**Document title:** SNL Responses to Public Comments and Citizen Action  
Comments on the Mixed Waste Landfill Corrective Measures  
Implementation Plan, April 2006

**SNL RESPONSE TO PUBLIC COMMENTS  
AND CITIZEN ACTION COMMENTS  
ON THE  
MIXED WASTE LANDFILL  
CORRECTIVE MEASURES IMPLEMENTATION PLAN**

**Review of Sandia National Laboratories'  
Mixed Waste Landfill Corrective Measure Implementation Plan  
and  
Fate and Transport Model:**

Figure 22. Simulated PCE groundwater concentrations for 100 realizations.

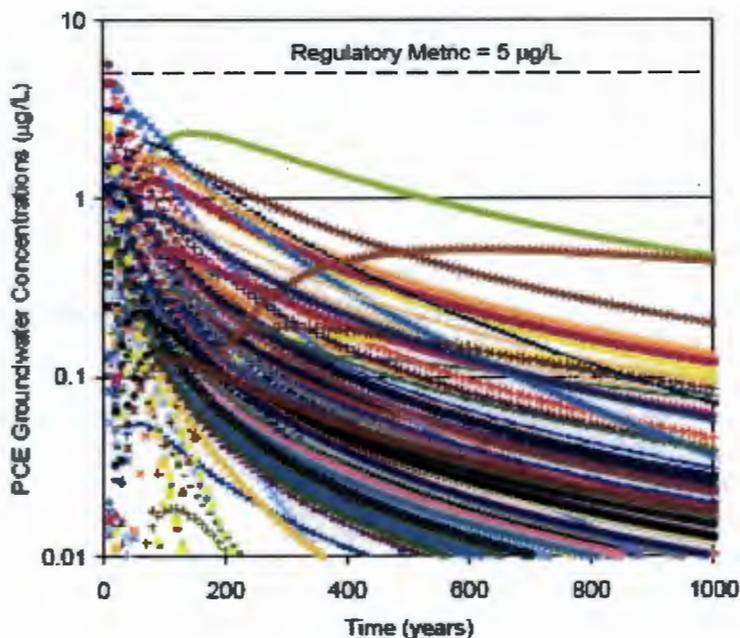
The FTM states: "Figure 22 [on p. 55] shows the simulated PCE concentrations in the groundwater as a function of time for all 100 realizations. The majority of the realizations show the aquifer concentrations peaking before 50 years. Depending on the time of disposal, this corresponds to peak concentrations occurring by 2010 – 2040. [emphasis added]. To date, no detectable amounts of PCE have been found in the groundwater at the MWL. This is still consistent with the simulations which show a large amount of variability in the simulated concentrations resulting from uncertainty included in the input parameters." FTM at pp. 54-55. Figure 22 is attached these comments as APPENDIX A.

Figure 23. Cumulative probability for simulated PCE peak groundwater concentrations for 100 realizations.

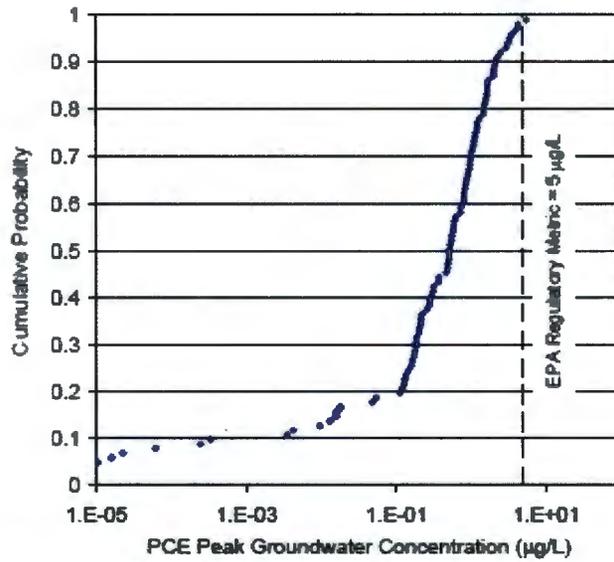
Figure 23 in the FTM shows the concentration of PCE anticipated in the groundwater by the model realizations. This figure shows that the vast majority of the realizations – about 80% - show PCE levels in the groundwater in the range of 1 – 5 micrograms per liter, equivalent to parts per billion. Prediction of those concentrations of PCE reaching the groundwater represent a prediction of significant contamination as PCE is not naturally occurring and therefore **zero** PCE would be predicted to have reached groundwater if no PCE were already shown to have escaped from the MWL. Figure 23 is attached to these comments in APPENDIX A.

*SNL Response: In contrast to the statement above, only 30% (not 80%) of the realizations results in groundwater concentrations ranging from 1 – 5 micrograms per liter. Only 1% of all the realizations show a groundwater concentration that exceeds the regulatory metric of 5 micrograms per liter.*
